RENOVATIONS

**OLD WOODBRIDGE FIRE STATION  
4 NEWTON ROAD  
WOODBIDGE, CT 06525  
BID #2018-13**

**DATE: May 31, 2018**

The following changes to the Drawings and Project Specifications shall become a part of the Drawings and Project Specifications; superseding previously issued Drawings and Project Specifications to the extent modified by Addendum No. 1.

**RTU TERMINATION BAR DETAIL**  
SCALE: 1/2" = 1'-0"

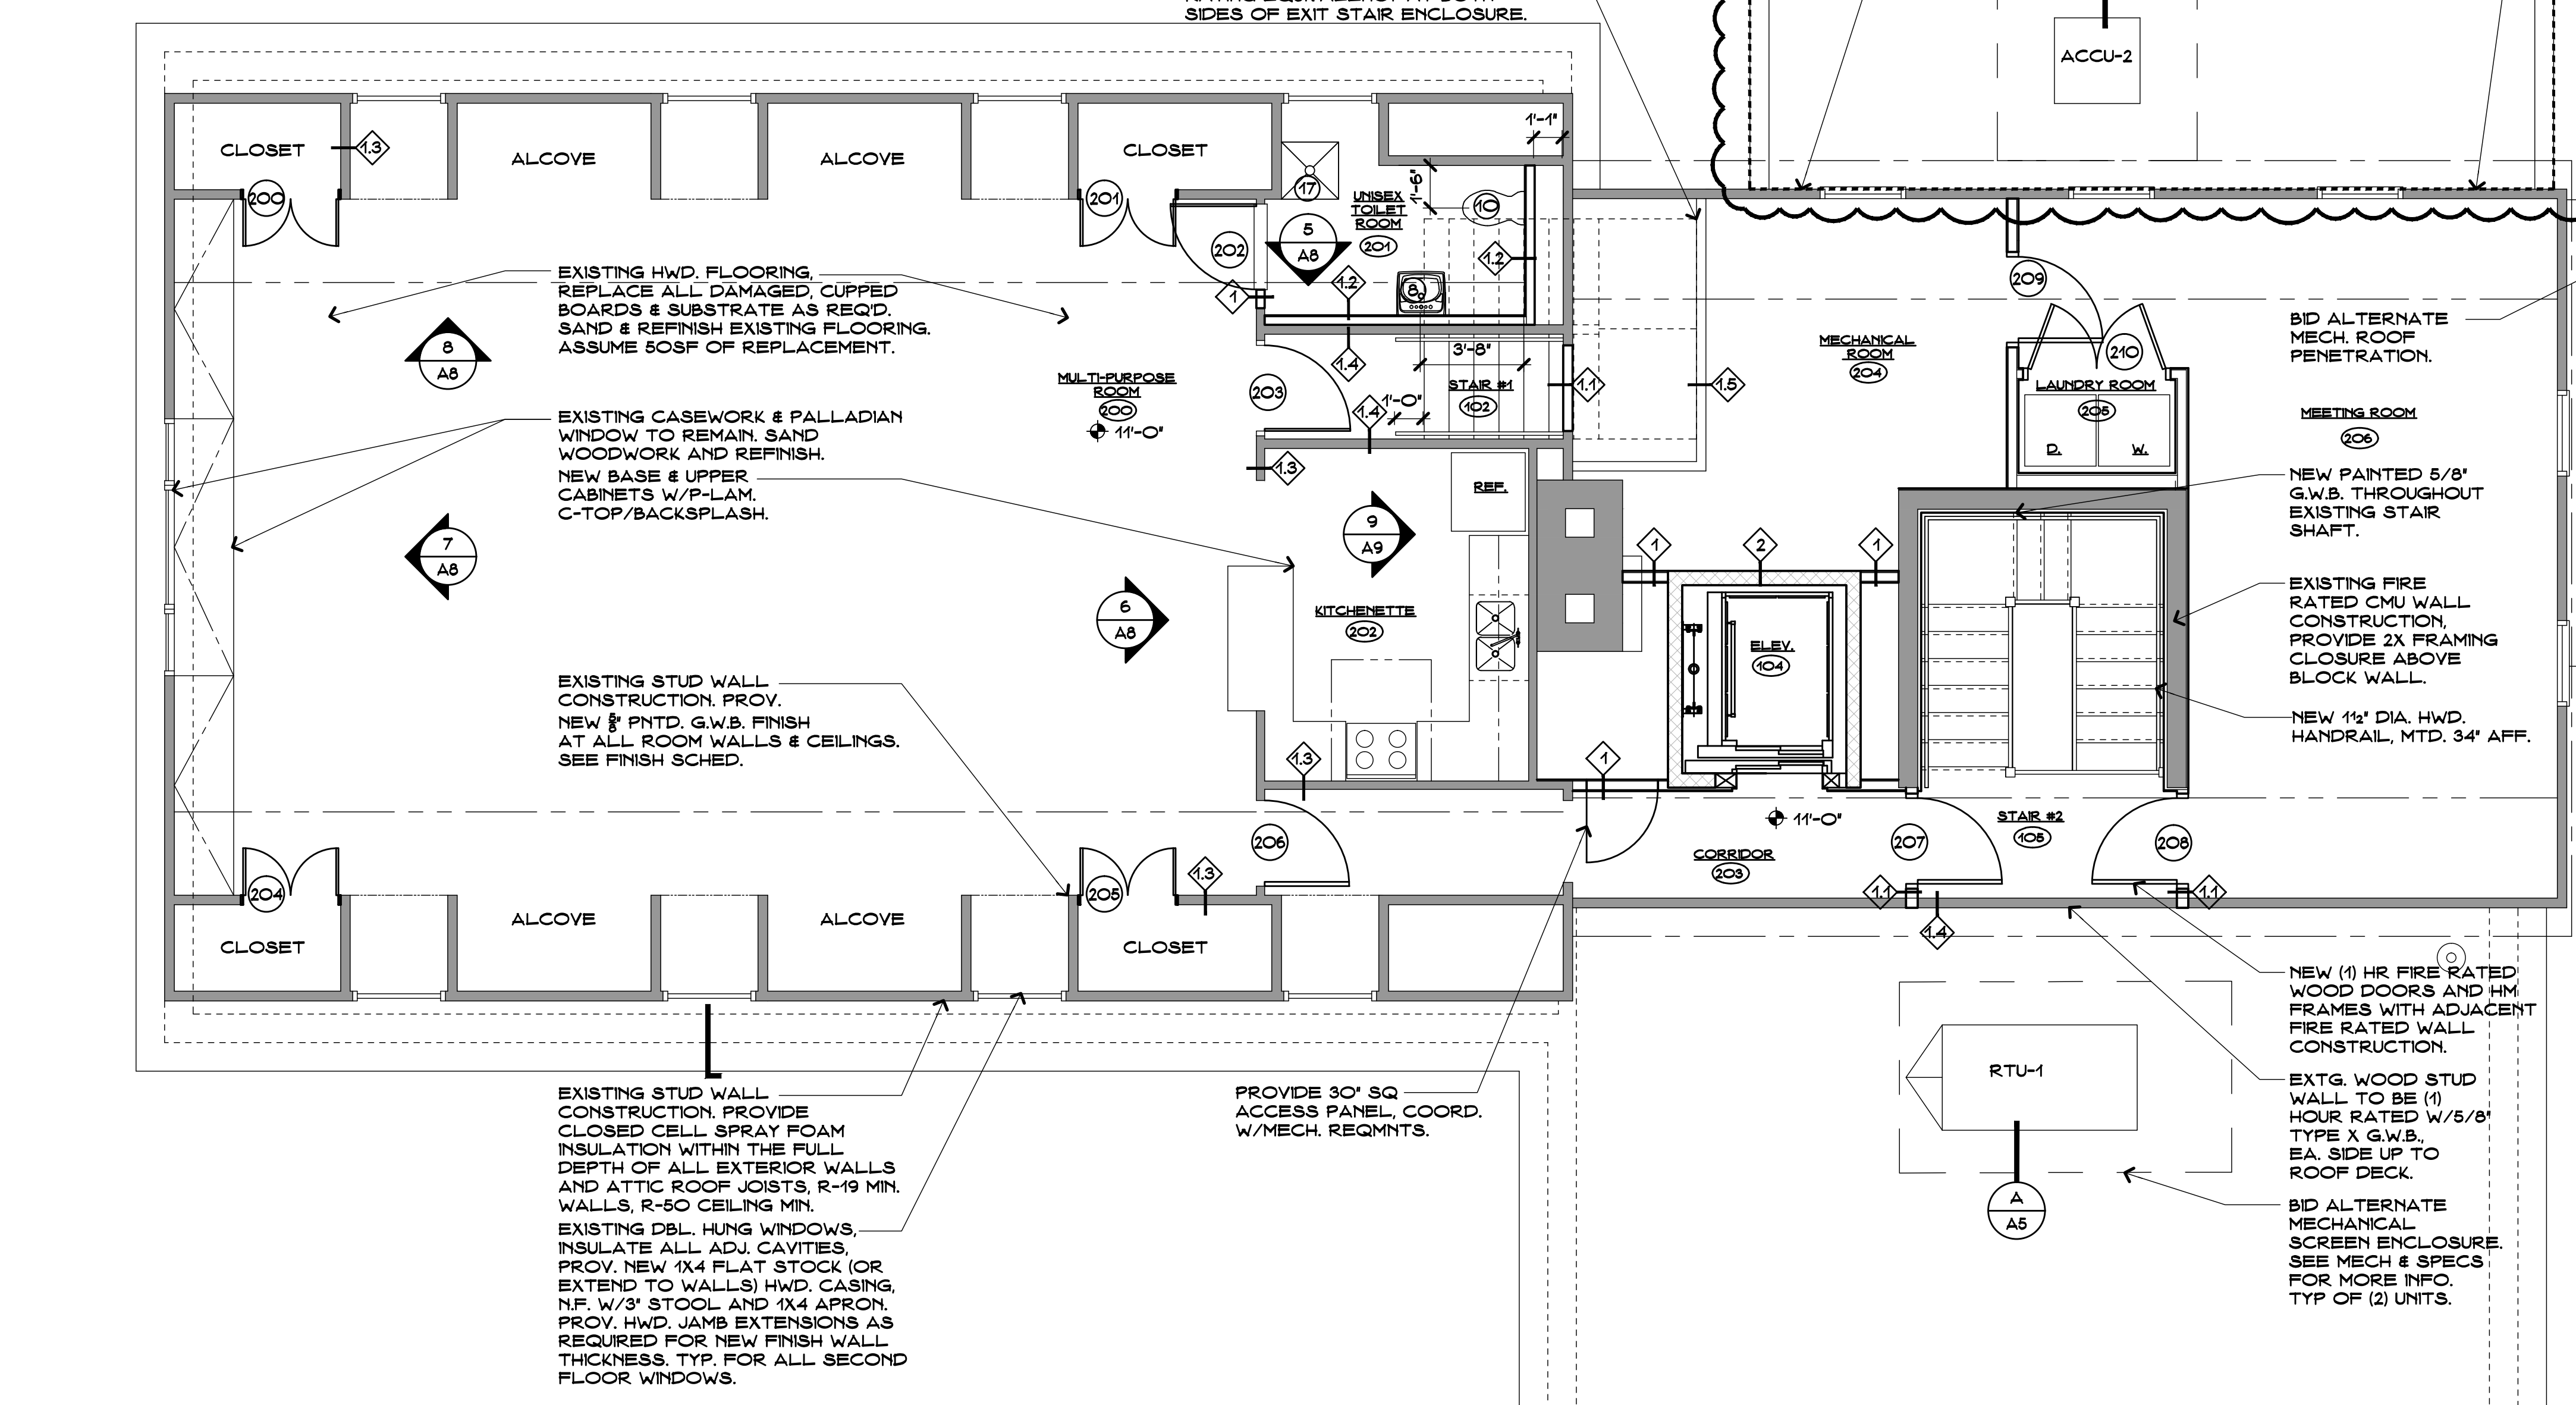
“E. **ADD ALTERNATE NO. 5: Roof Replacement:** Add to the Base Bid the labor, material and equipment to remove the existing rolled roofing down to deck where indicated in Drawing A5. Work will include the provision and installation of new insulation, EPDM membrane, sheet metal flashing and trim, and all associated components for a weathertight installation. Refer to Sections 075323 and 762000 for additional information.”
- SECTION 024119, SELECTIVE DEMOLITION, Page 3, Article 1.9.D., revise to read as follows:

**ROOFING BID ALTERNATE**  
REMOVE EXISTING ROLLED ROOFING. PROVIDE NEW POLY-ISO INSULATION, MIN R VALUE OF 25. REMOVE ALL EXISTING METAL COPINGS AND ROOF DRAINS. EXTEND NEW EPDM MEMBRANE UP/OVER PARAPET WALLS/CURB. PROV. NEW IN-KIND COPPER COPING. SEAL ALL METAL JOINTS. EXISTING PRIMARY ROOF DRAIN SHALL BE REINSTALLED.

**SECOND FLOOR PLAN**  
SCALE: 1/8" = 1'-0"

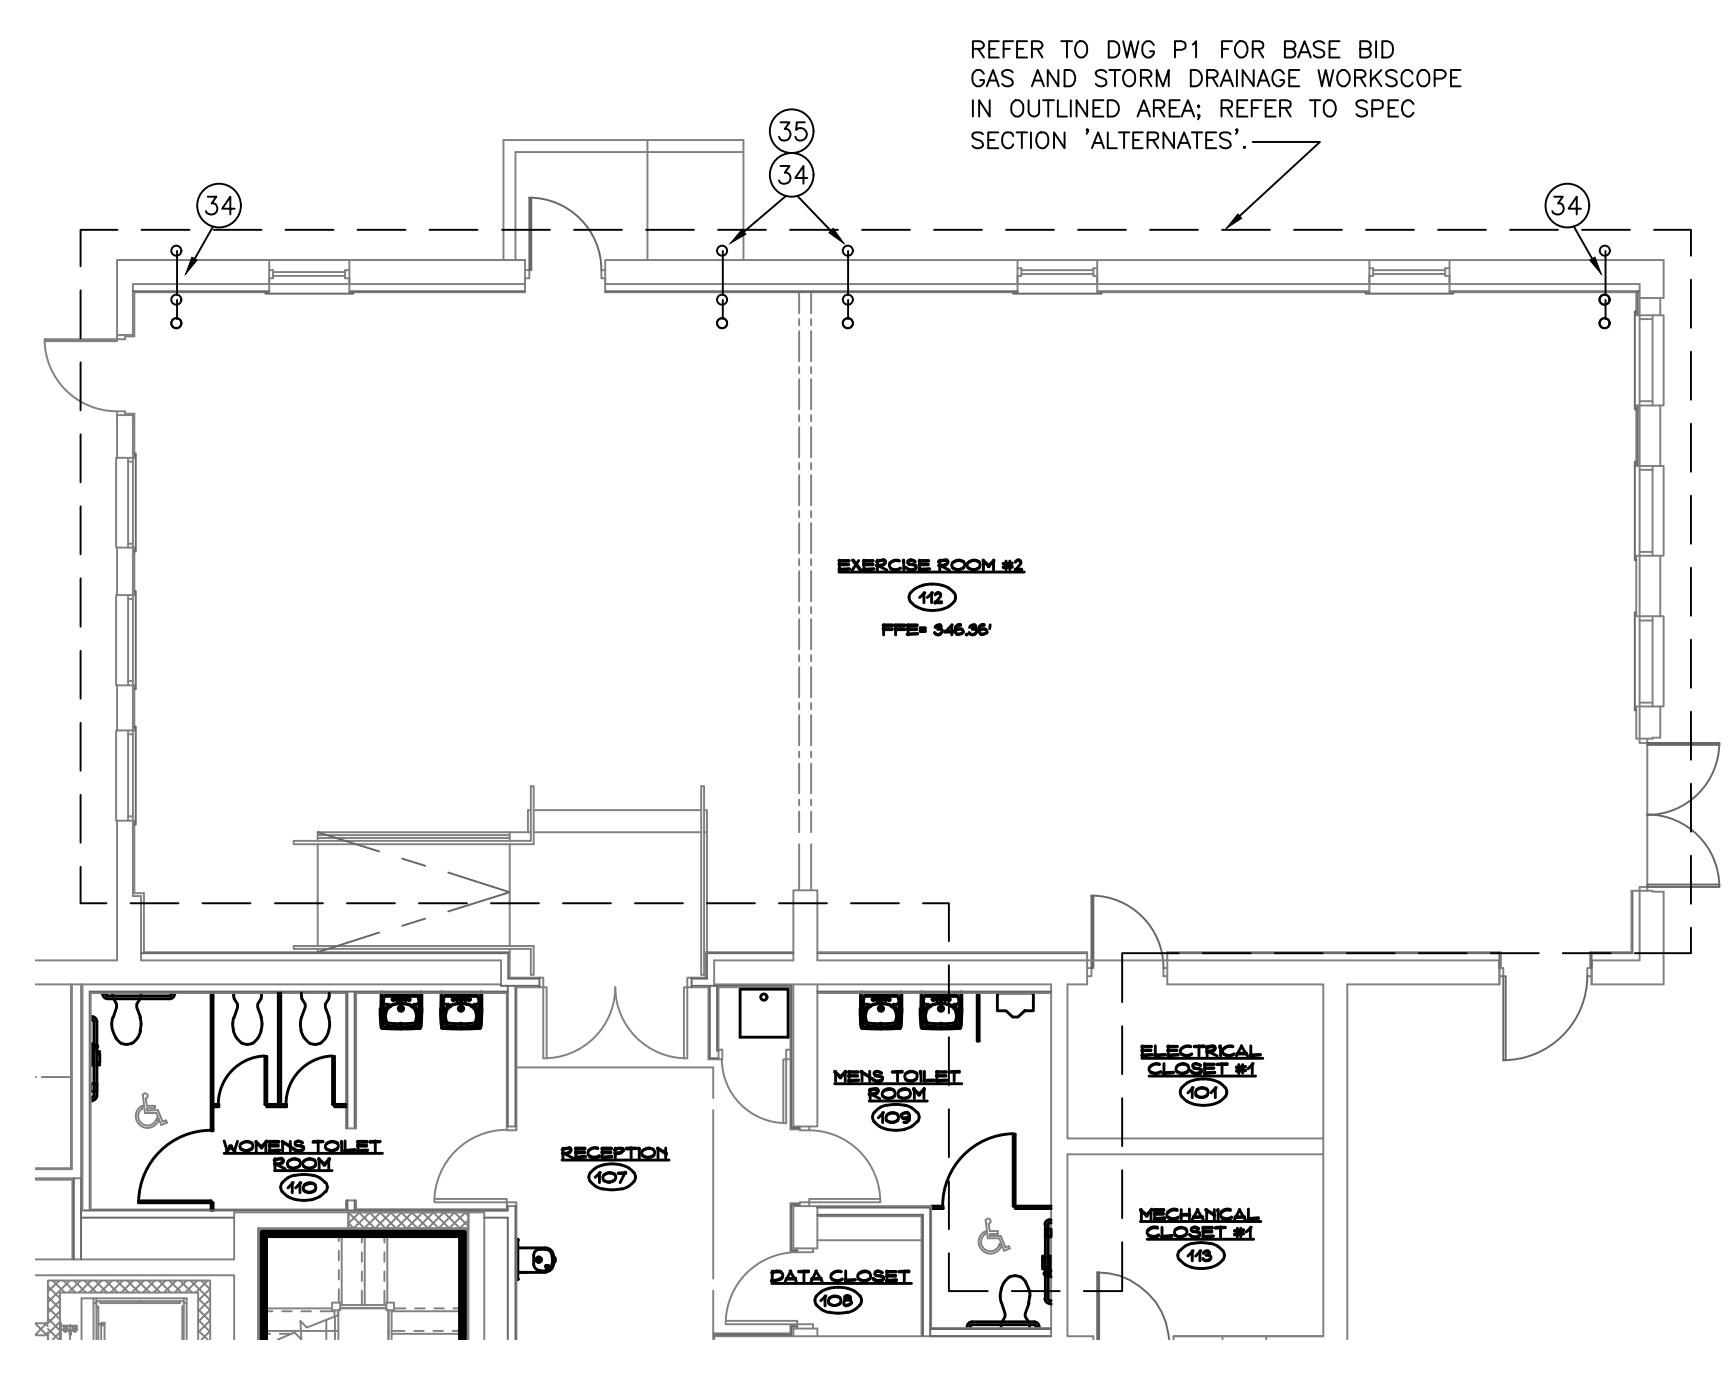
- DRAWING A5, SECOND FLOOR PLAN & DOOR SCHEDULE has been deleted in its entirety. A new DRAWING A5 has been added and is attached as part of this addendum.\*
